MEMORANDUM

Subject: Comments Regarding California America Water Monterey Peninsula Water Supply Project Draft Environmental Impact Report/Environmental Impact Statement, Released 13 January 2017
Marina Coast Water District, California
(EKI B60094.01)

Figure 5

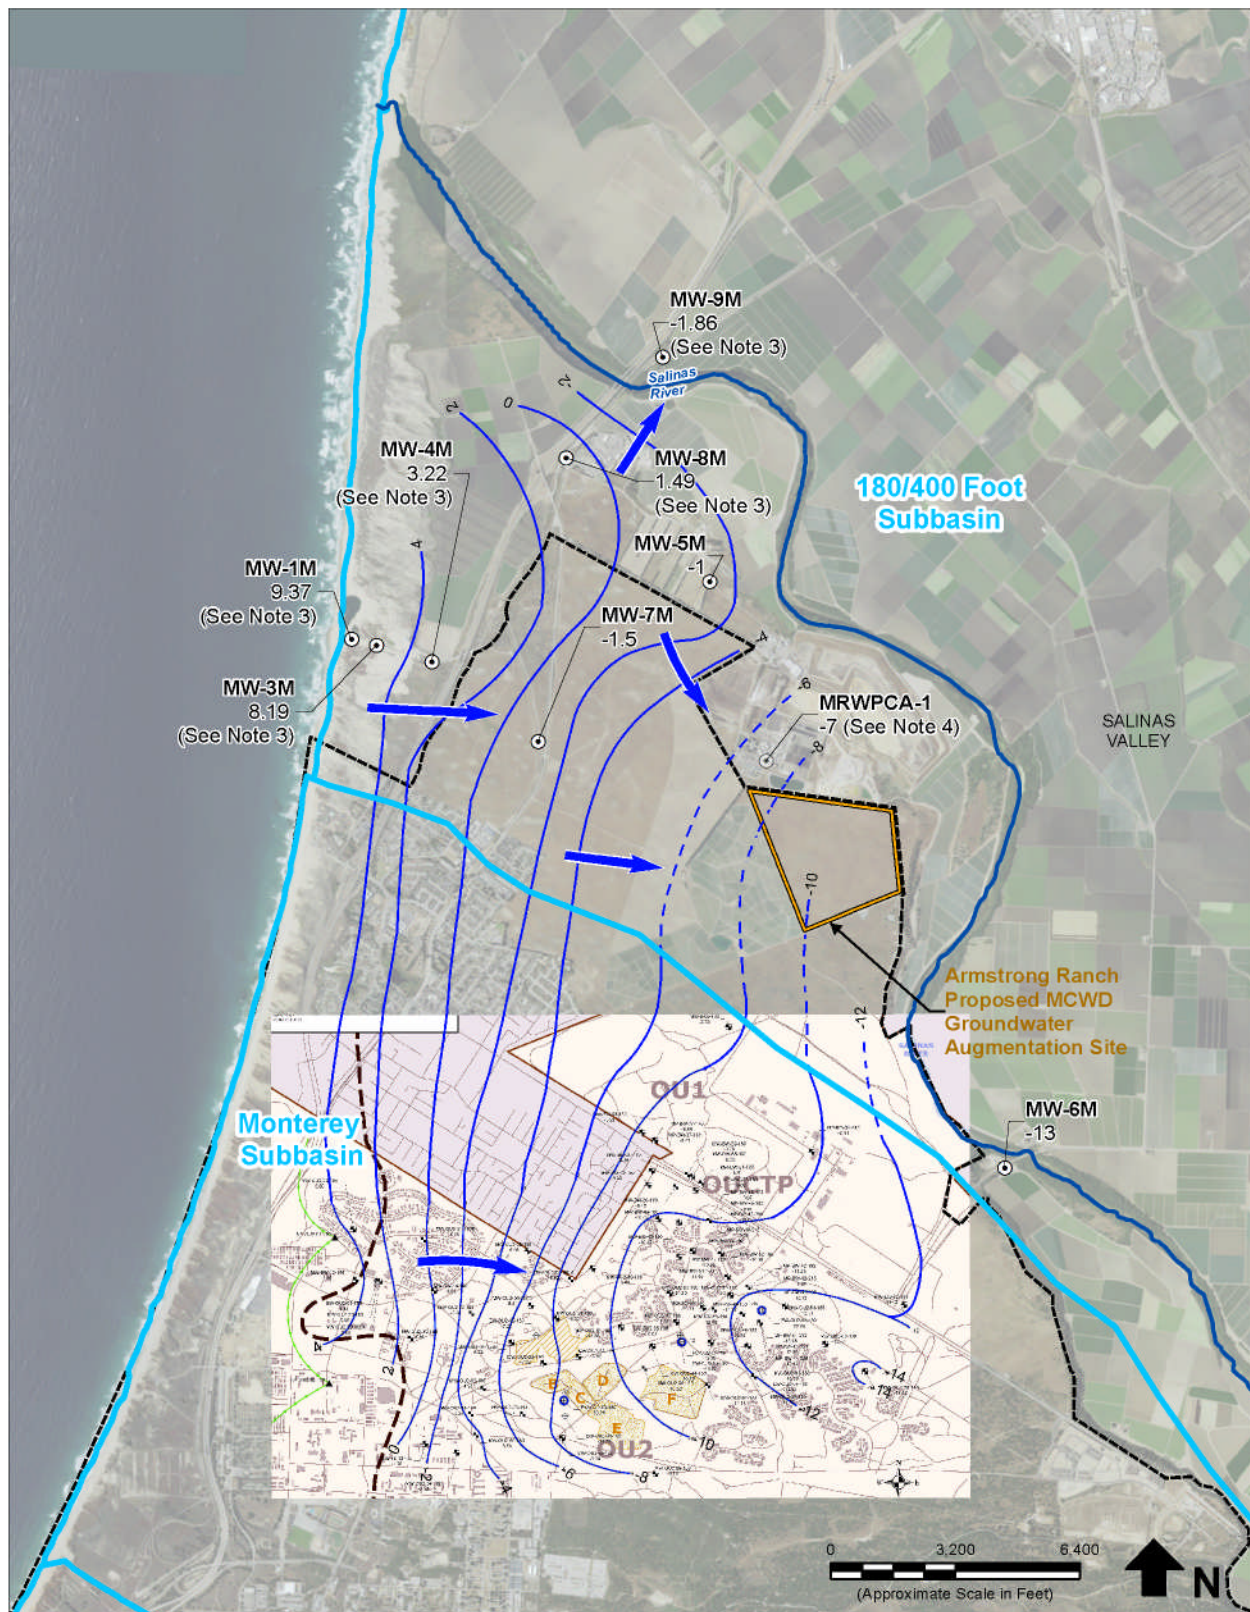
As shown on Figure 5, groundwater in the Dune Sand Aquifer in the northern portion of MCWDs Service Area is significantly above sea level and flows west towards Monterey Bay. In contrast, as shown in Figure 6, groundwater in the 180-Foot Aquifer flows eastward towards a regional pumping center in the interior of the Salinas Valley. Based on the head differences between these aquifers it is apparent that the Dune Sand Aquifer is "perched" on the Salinas Valley Aquitard in inland areas but has some degree of connection with the 180-Foot Aquifer as one moves west towards the Bay (i.e., the head difference between the two aquifer systems lessens near the Project Site).

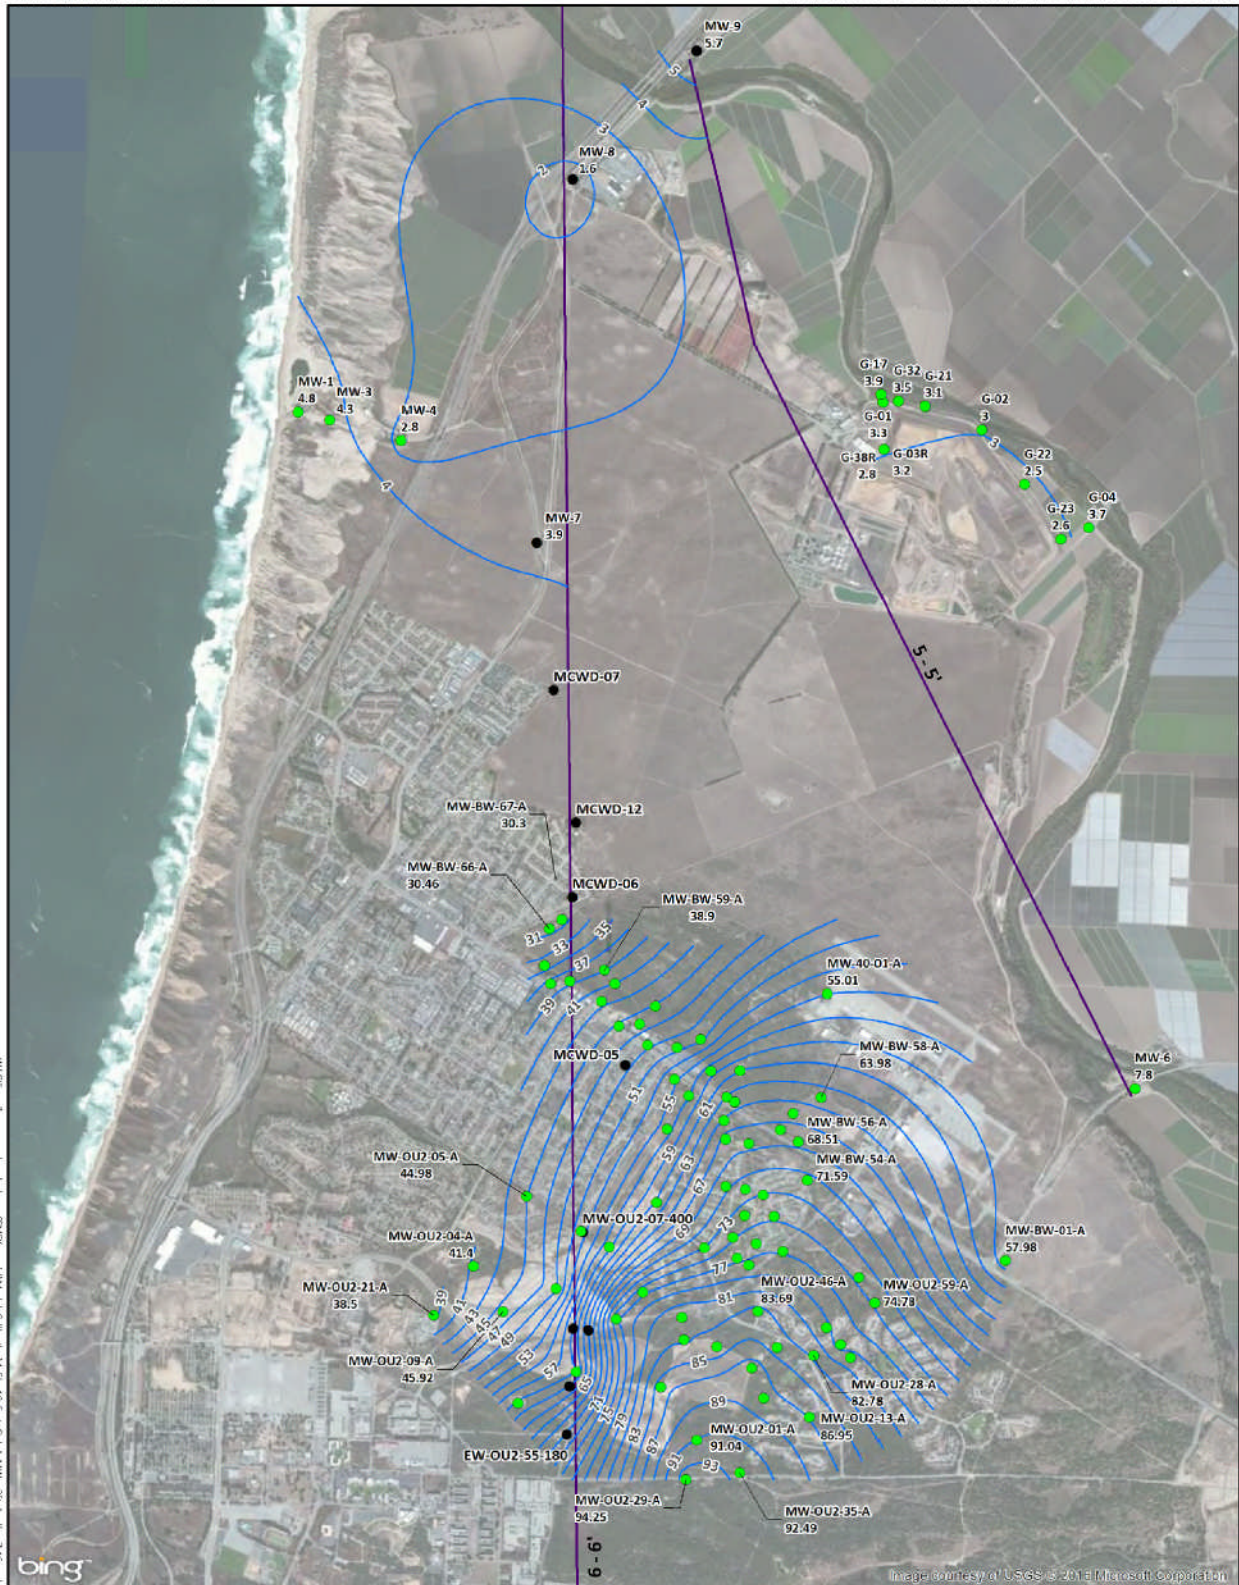
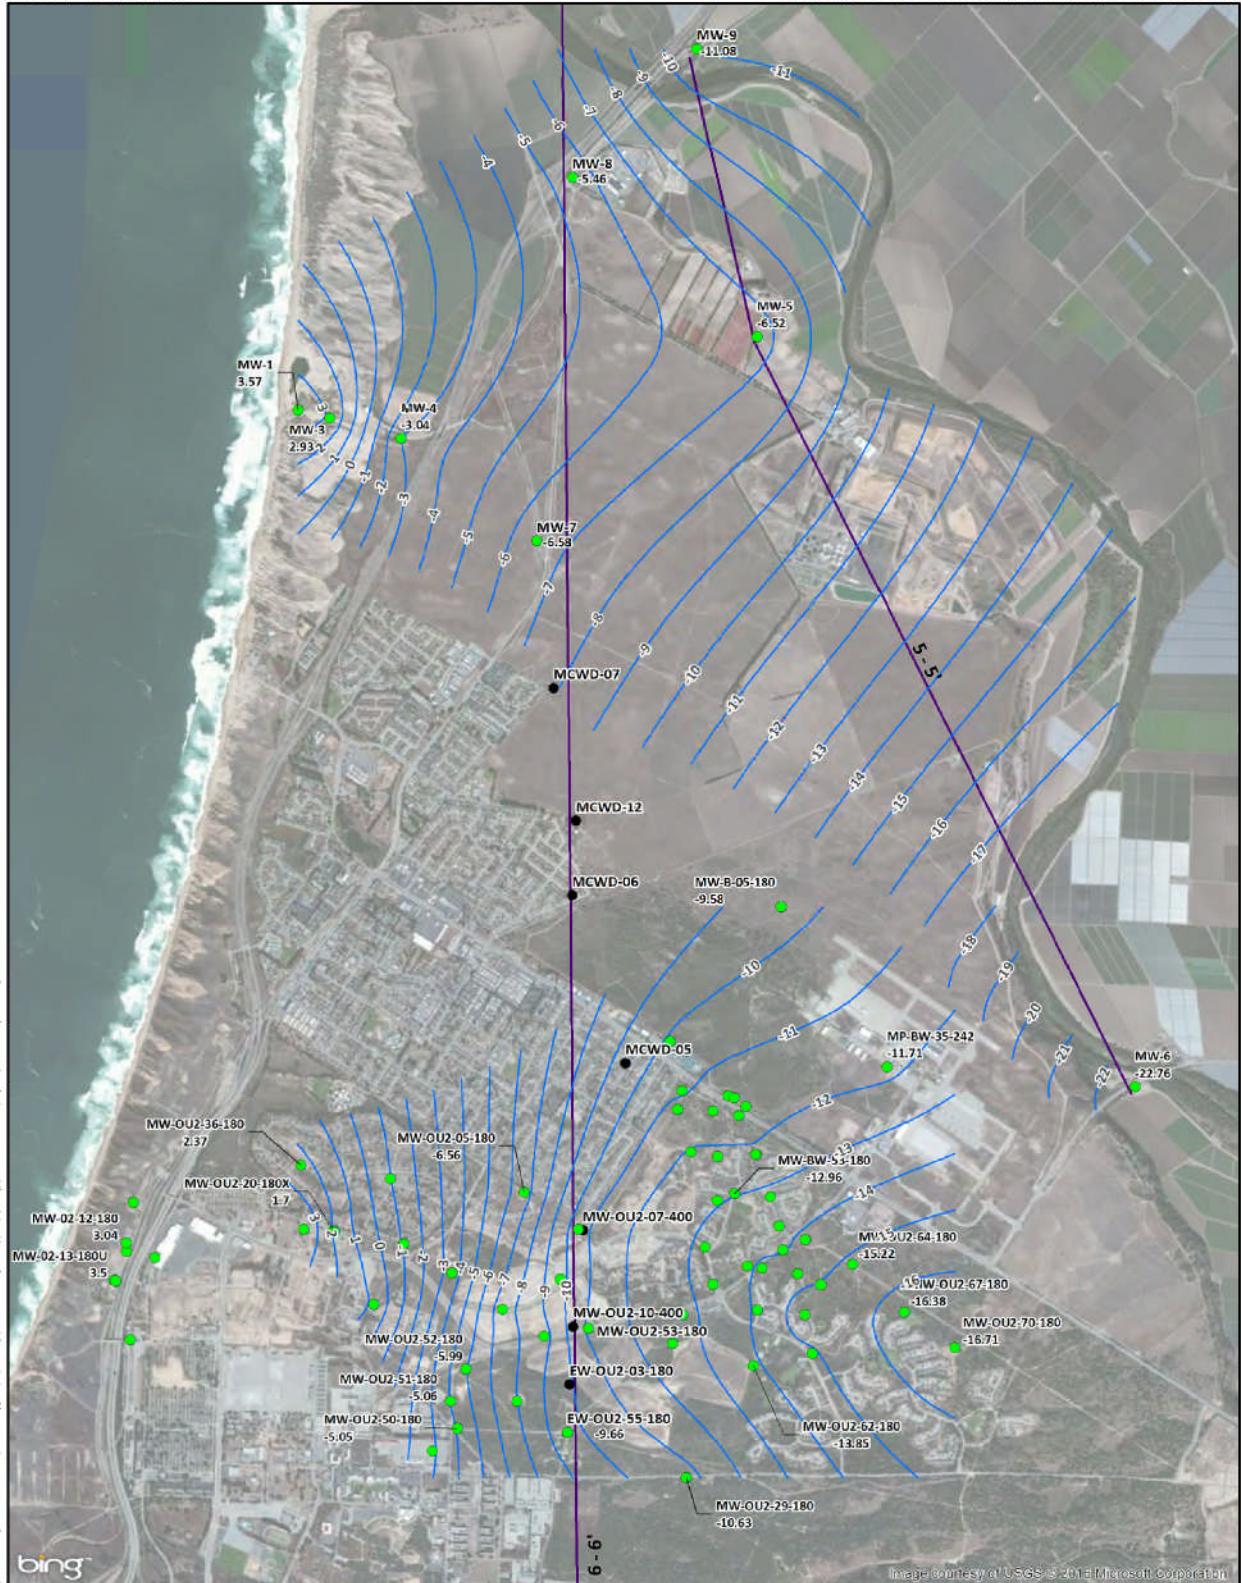
Draft Technical Memorandum No.2 ("TM2") referenced in the DEIR/EIS (Geosciences, 2016), includes water level maps for the Dune Sand Aquifer and 180-Foot Aquifer⁶. However, these maps further complicate and obscure the continuity of groundwater flow within the Dune Sand Aquifer, by separating this aquifer into a "perched zone" and "-2 foot aquifer zone", and incorrectly imply that groundwater flow is discontinuous between Fort Ord and the northern portion of MCWD service area in both the Dune Sand and 180-Foot Aquifers. Copies of these maps are presented in Appendix B hereto.
